IEEE P802.15 Wireless Personal Area Networks

Project	IEEE P802.15 Working Group for Wireless Personal Area Networks (WPANs)	
Title	MSCs Incorporating New FCSL/DME/MLME Functional Division and Imm-ACK Removal	
Date Submitted	[14 July, 2004]	
Source	[John Sarallo] [Appairent Technologies] [150 Lucius Gordon Drive, West Henrietta, NY 14586]	Voice: [585-727-2014] Fax: [585-214-2461] E-mail: [sarallo@appairent.com]
Re:		
Abstract	[This document contains a list or proposed changes to IEEE Std 802.15.3.]	
Purpose	[The purpose of this document is to propose changes to IEEE Std 802.15.3 to improve compatibility, performance and clarity in the standard.]	
Notice	This document has been prepared to assist the IEEE P802.15. It is offered as a basis for discussion and is not binding on the contributing individual(s) or organization(s). The material in this document is subject to change in form and content after further study. The contributor(s) reserve(s) the right to add, amend or withdraw material contained herein.

This document presents new clause 8 MSCs resulting from Imm-ACKs no longer being used as confirmation commands as presented in 04/202r0 and with the following functional division

Figure 125 - MSC of a DEV synchronizing with a PNC

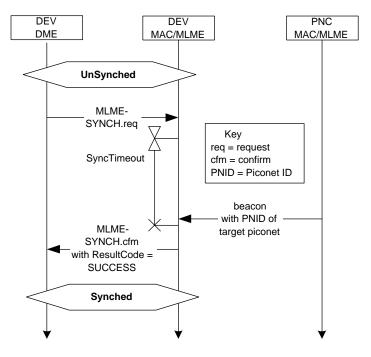
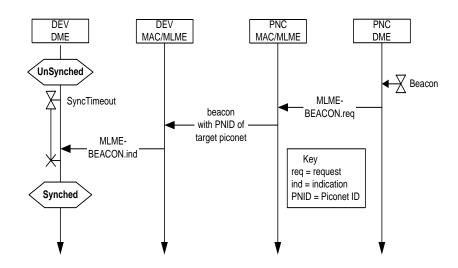
• DME can sync itself because it receives beacon indications. Therefore, MLME-SYNCH primitives are no longer needed.

Figure 102 - MSC of DEV-2 associating

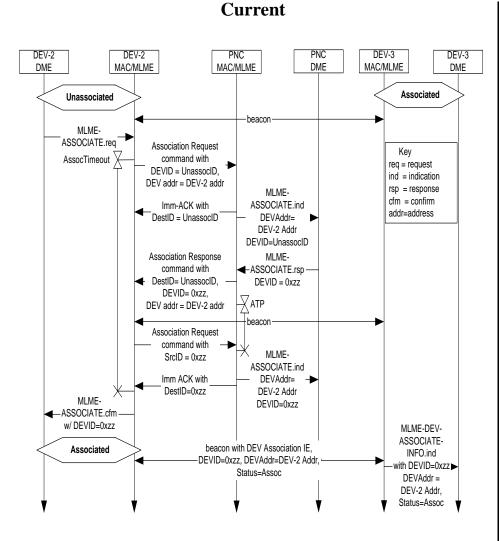
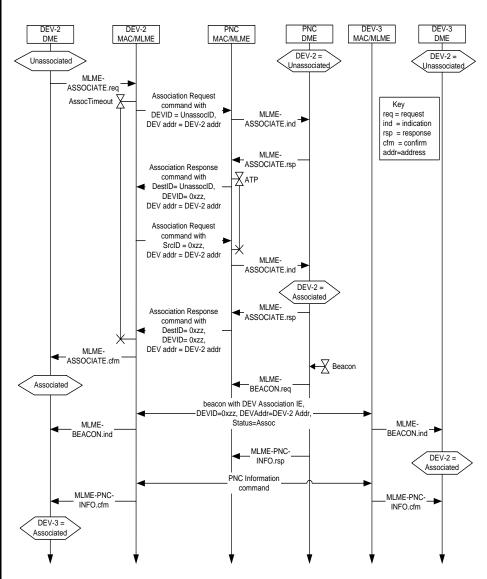
Requesting DEV knows it is associated when it receives the second Association Response command. Other DEVs in the piconet know when they receive a beacon with a DEV Association IE. The associating DEV learns of other DEVs via the PNC Information command.

Figure 103 - PNC sending the Piconet Services command to a newly associated DEV in response to a request in the association process

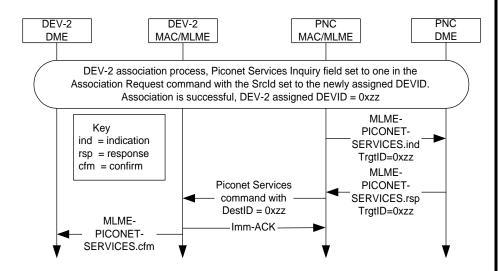
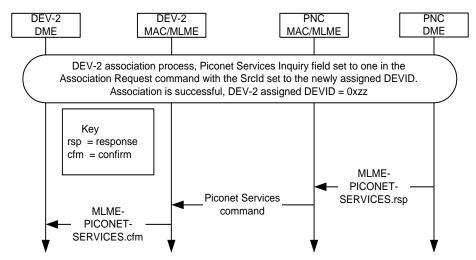
• PME is aware when a DEV associates with the Piconet Services Inquiry field set therefore the PNC MAC/MLME does not need to send an indication to the PME.

Figure 104 - DEV initiated disassociation MSC

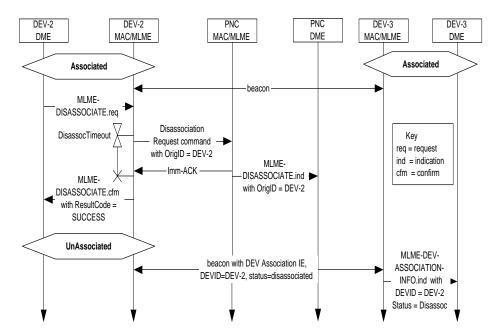
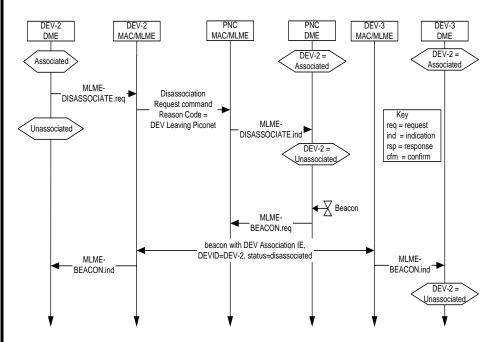
- DEV initiated disassociation is a "fire and forget" scenario.
- Disassociating DEV can immediately mark itself as disassociated.
 Other DEVs know when they receive a beacon with a DEV Association IE.

Figure 105 - PNC initiated disassociation MSC

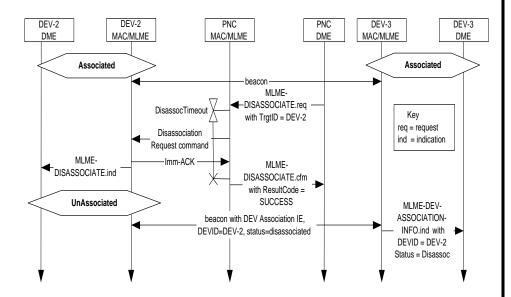
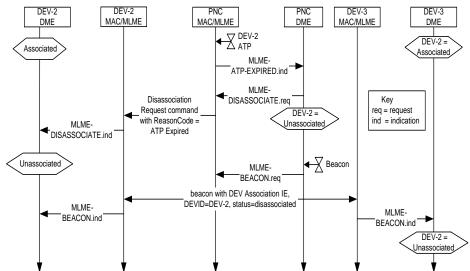
- PNC initiated disassociation is a "fire and forget" scenario.
- DEV is disassociated when it receives a MLME-DISASSOCI-ATE.ind. Other DEVs know about the disassociation when they receive a beacon with a DEV Association IE.
- If a DEV receives a beacon with a DEV Association IE indicating it is disassociated, it should consider itself disassociated.
- Took opportunity to add MLME-ATP-EXPIRED.ind to at least one MSC (Note: MAC/MLME must maintain ATP timers because the DME does not see data frames.)

Figure 114 - MSC for creating a DEV-2 to DEV-3 stream

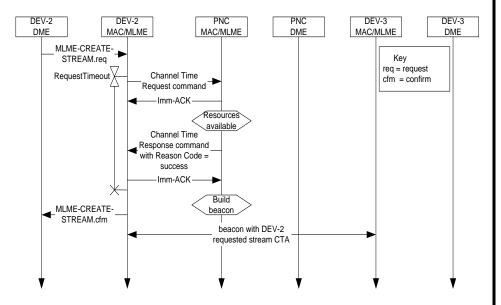
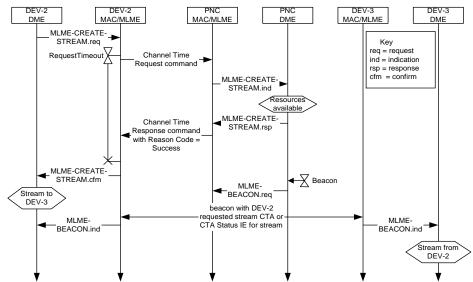
- PME is responsible for channel time allocation so MLME-CREATE-STREAM indication and response primitives are required.
- Requesting DEV knows stream is created when it receives the Channel Time Response command.
- Target DEV knows about the stream when it receives a beacon with a CTA or CTA Status IE indicating it is the target of a stream.

Figure 117 - MSC for modifying a stream

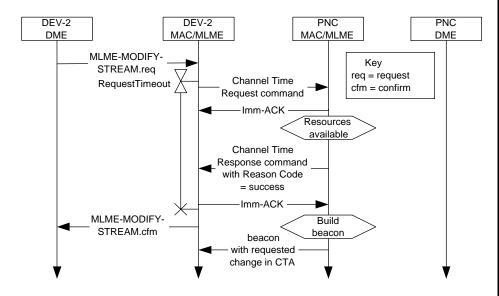
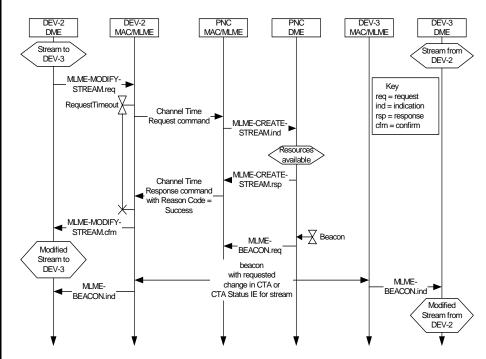
- Requesting DEV knows stream is modified when it receives the Channel Time Response command.
- Target DEV knows about the stream modification when it receives a beacon with a modified CTA or a CTA Status IE.

Figure 120 - MSC of source DEV-2 requesting termination of its stream

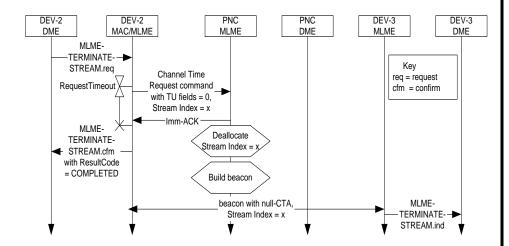
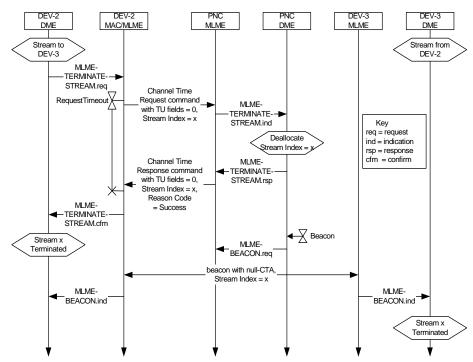
• If the we desire the target to know why a stream was terminated, then the target DEV must receive a Channel Time Response command. Otherwise, it will know the stream is terminated when it receives the Null CTA but it will not know why the stream was terminated.

Figure 121 - MSC of target DEV-3 requesting termination of source DEV-2's stream

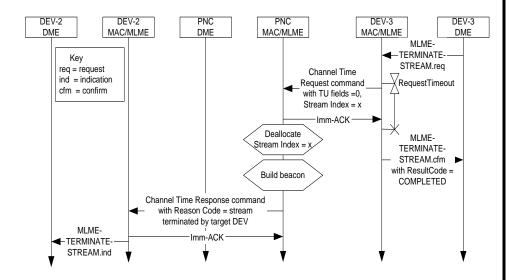
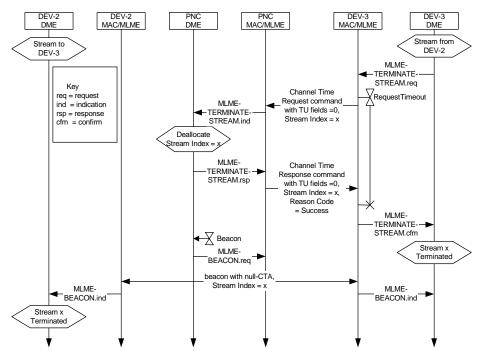
If the we desire the strean source to know why the stream was terminated, then the source DEV must receive a Channel Time Response command. Otherwise, it will know the stream is terminated when it receives the Null CTA but it will not know why the stream was terminated.

Figure 122 - MSC of PNC terminating a stream

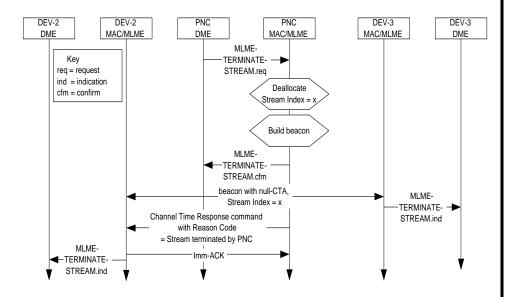
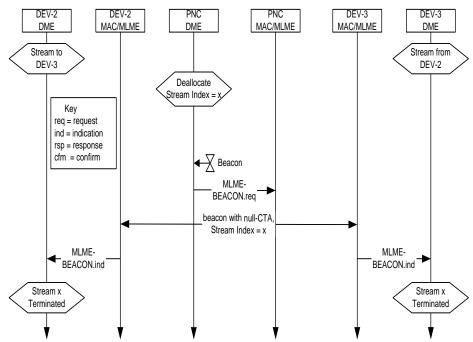
• If the we desire the stream source and target to know why a stream was terminated, then both DEVs must receive a Channel Time Response command. Otherwise, both DEVs will know the stream is terminated when they receives the Null CTA but they will not know why the stream was terminated.

Figure 127 - MSC for acquiring information regarding a specific DEV or all of the DEVs from the PNC using the PNC Information Request and PNC Information commands

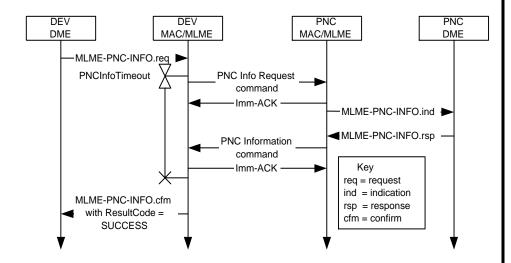
• Only change is Imm-ACKs removed.

Figure 128 - MSC for acquiring DEV IEs using the Probe Request and Probe Response commands

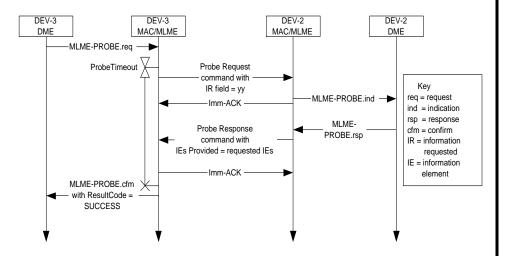
• Only change is Imm-ACKs removed.

Figure 130 - MSC for determining the channel status between two DEVs using the Channel Status Request and Channel Status Response commands

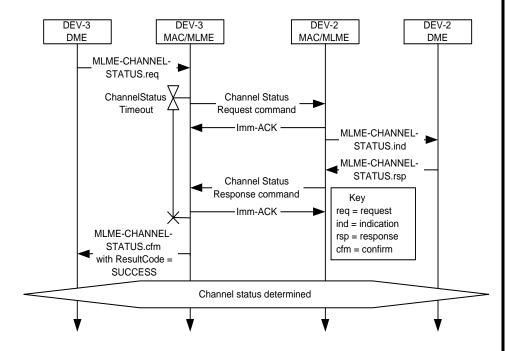
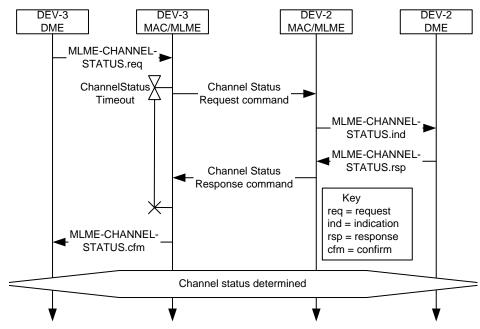
Only change is Imm-ACKs removed.

Figure 131 - Remote scan MSC

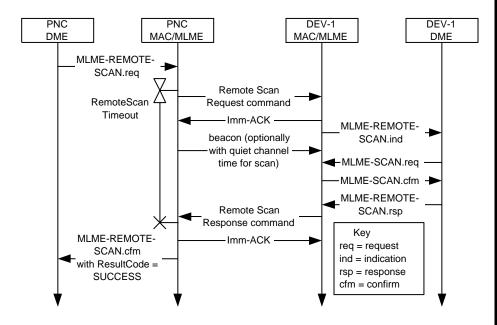
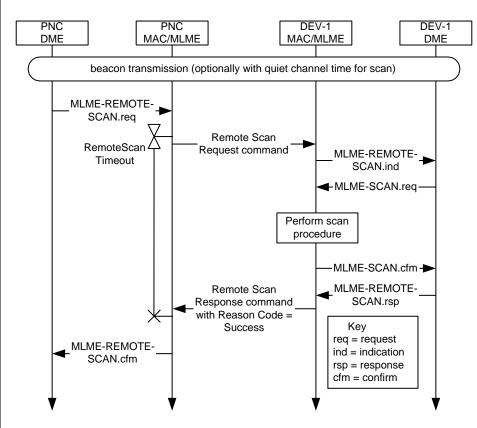
• Only real change is Imm-ACKs removed.

Figure 134 - MSC for changing either the PNID or BSID for a piconet

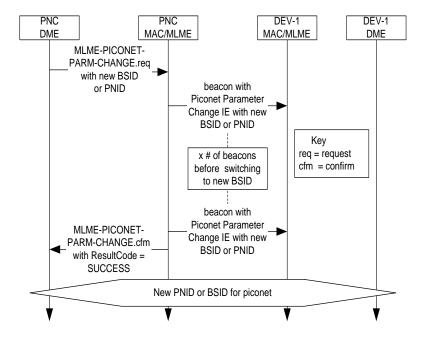
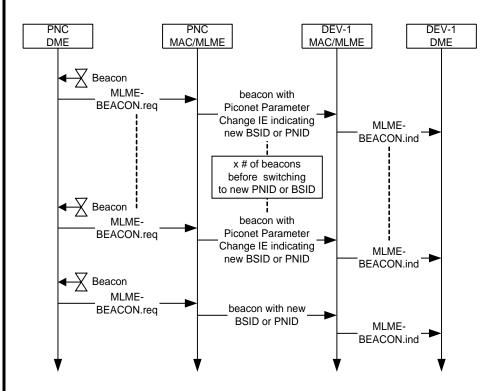
PME is responsible for information in the beacon so the MLME-PICONET-PARM-CHANGE primitives are no longer needed.

Figure 136 - Transmit power change MSC

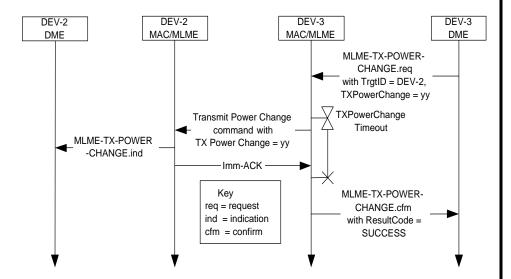
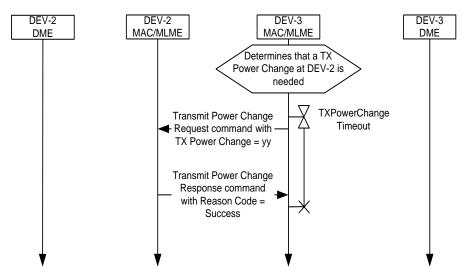
MAC/MLME responsible for TX power adaptation, therefore MLME-TX-POWER-CHANGE primitives are no longer needed.

Figure 140 - MSC for PS set information exchange

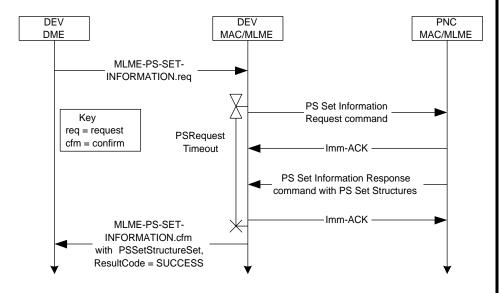
PME is responsible for maintaing power set information, therefore, MLME-PS-SET-INFORMATION indication and response primitives are needed.

Figure 141 - MSC for DSPS set creation

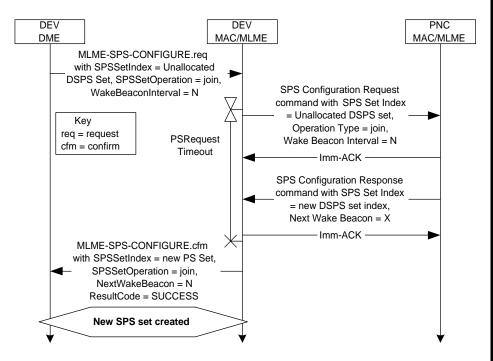
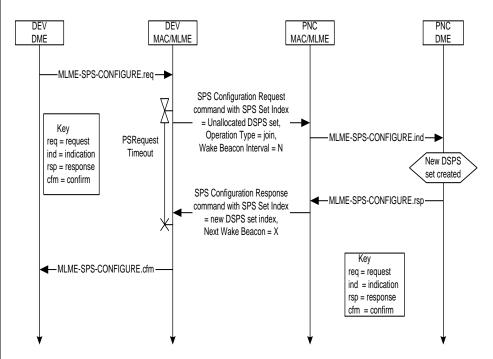
PME is responsible for maintaing power set information, therefore, MLME-SPS-CONFIGURE indication and response primitives are needed.

Figure 142 - MSC showing a DEV joining an existing SPS set

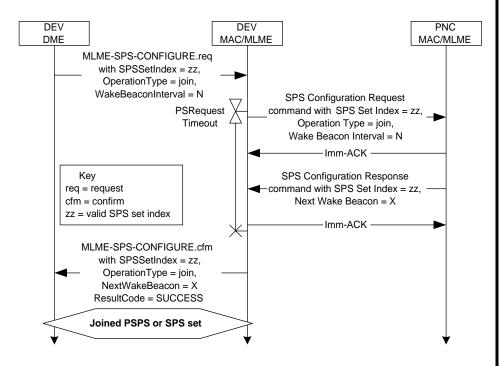
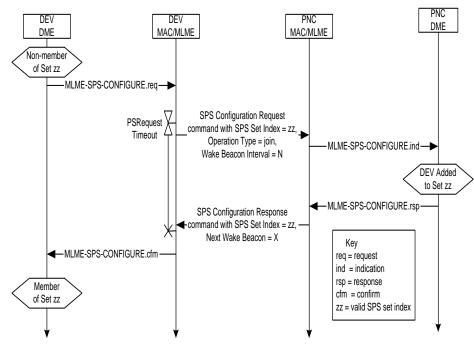
PME is responsible for maintaing power set information, therefore, MLME-SPS-CONFIGURE indication and response primitives are needed.

Figure 143 - MSC showing a DEV leaving an SPS set

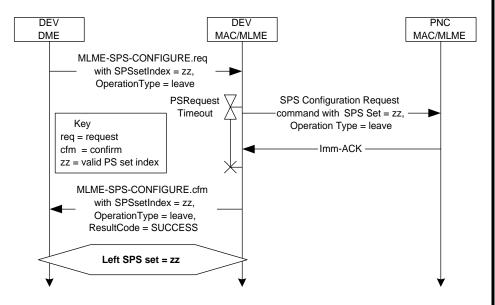
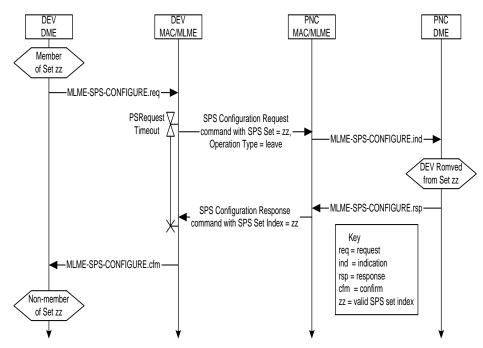
PME is responsible for maintaing power set information, therefore, MLME-SPS-CONFIGURE indication and response primitives are needed.

Figure 144 - MSC showing DME initiated PM mode change from ACTIVE to an SPS mode

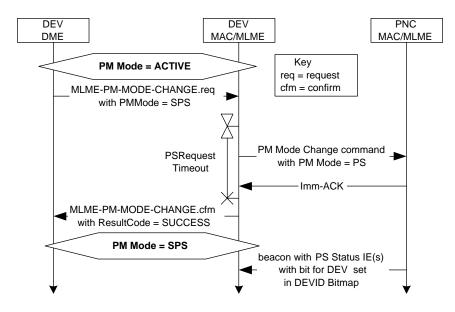
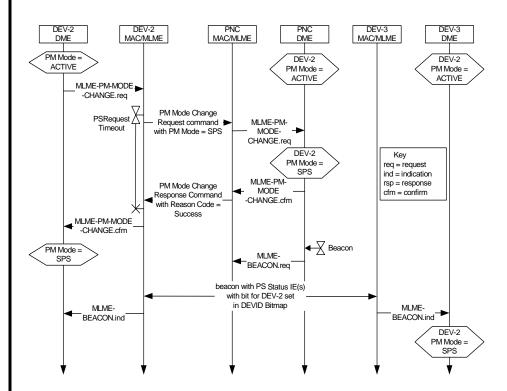
- PME is responsible for maintaing power save state information, therefore, MLME-PM-MODE-CHANGE indication and response primitives are needed.
- Other DEVs aware of mode change when they receive beacon.

Figure 145 - MSC showing DME initiated PM mode change from ACTIVE to APS

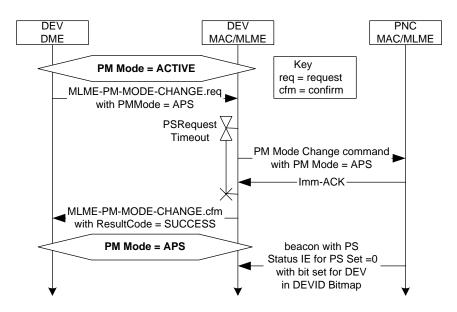
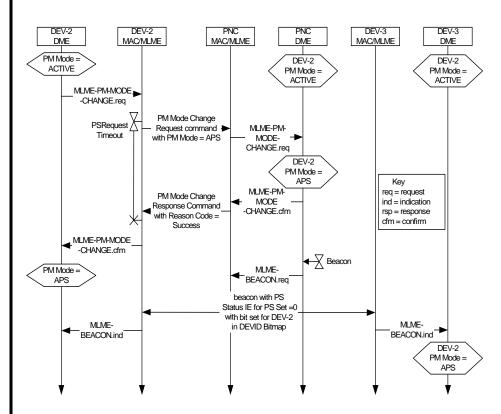
- PME is responsible for maintaing power save state information, therefore, MLME-PM-MODE-CHANGE indication and response primitives are needed.
- Other DEVs aware of mode change when they receive beacon.

Figure 146 - MSC showing DME initiated PM mode change from any PS mode to ACTIVE

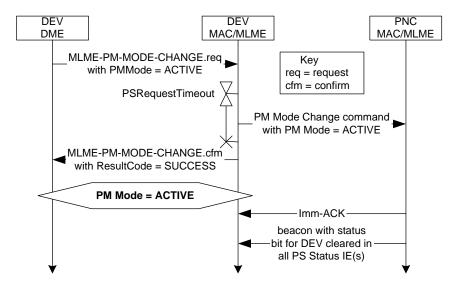
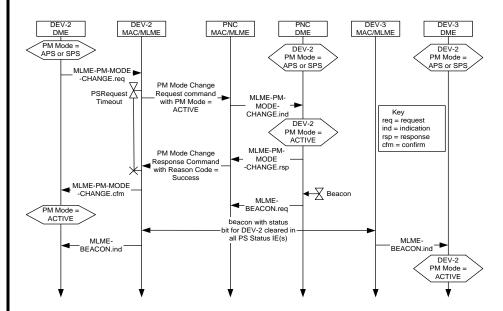
- PME is responsible for maintaing power save state information, therefore, MLME-PM-MODE-CHANGE indication and response primitives are needed.
- Other DEVs aware of mode change when they receive beacon.

Figure 147 - Message sequence showing MLME initiated PM mode change from DSPS to ACTIVE in response to a new chanel time allocation

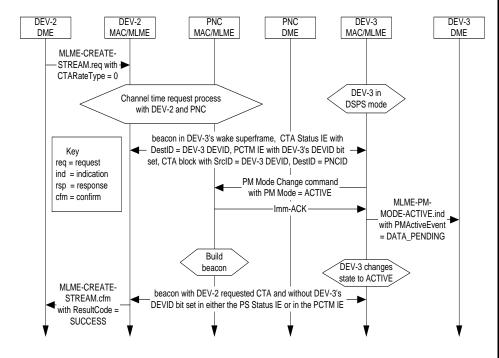
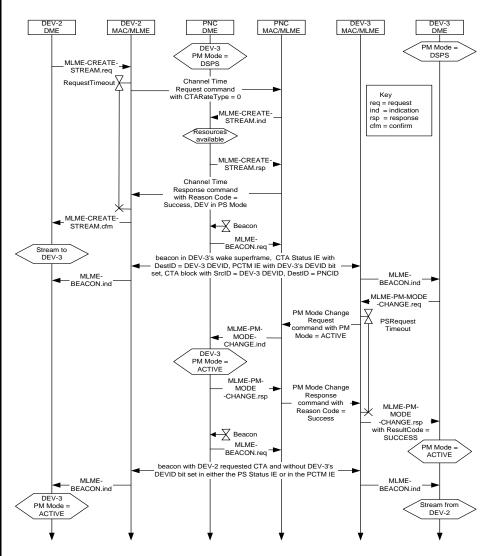
• To be consistent with other scenarios, requesting DEV is aware of stream when it receives a Channel Time Response command.

Figure 148—Message sequence chart for DEV-DEV Security information request

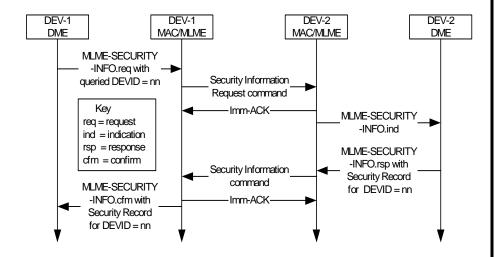
• Only change is Imm-ACKs removed.

Figure 149—Message sequence chart for New PNC-Old PNC Security Information transfer

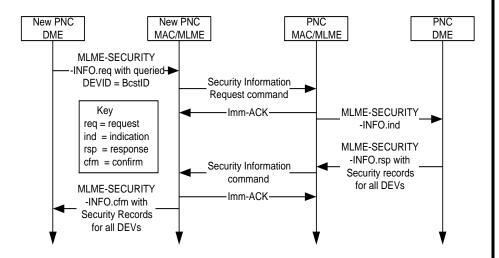
Only change is Imm-ACKs removed.

Figure 150—Message sequence chart for sending security information with the Security Message command

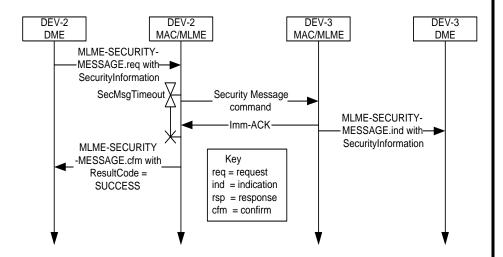
• Fire and forget so no confirm is needed.

Figure 152—Message sequence chart for peer-to-peer key distribution

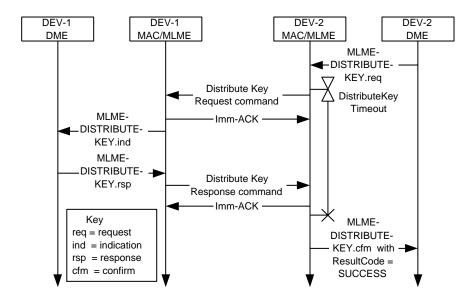
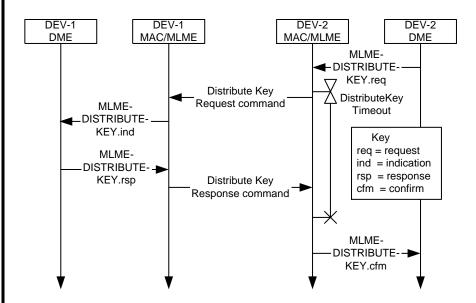
Only change is Imm-ACKs removed.

Figure 153—Message sequence chart for DEV key request

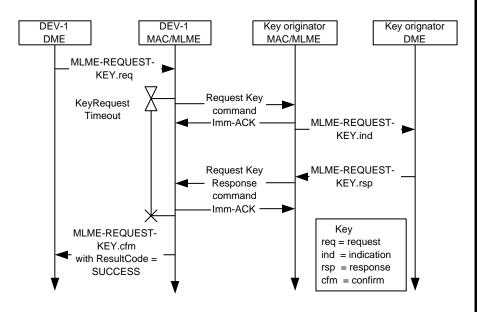
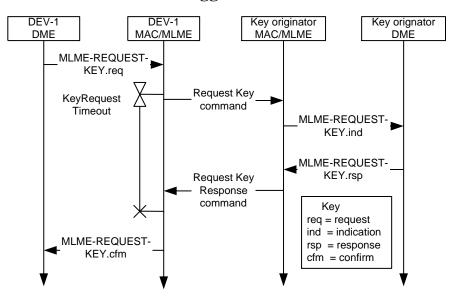
• Only change is Imm-ACKs removed.

Figure 94 - PNC handover MSC

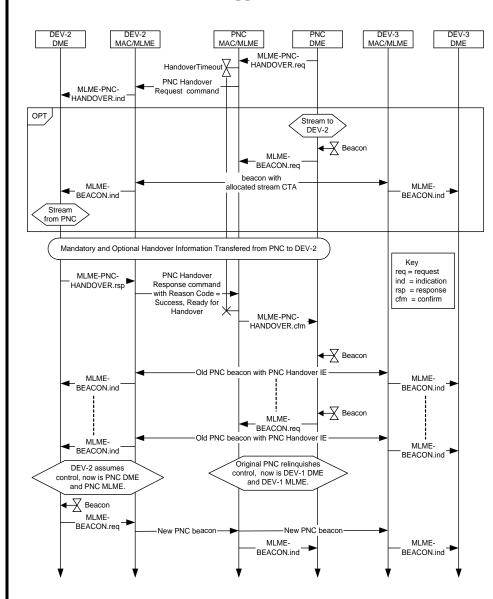
Shows handover data is optionally transferred in a stream.
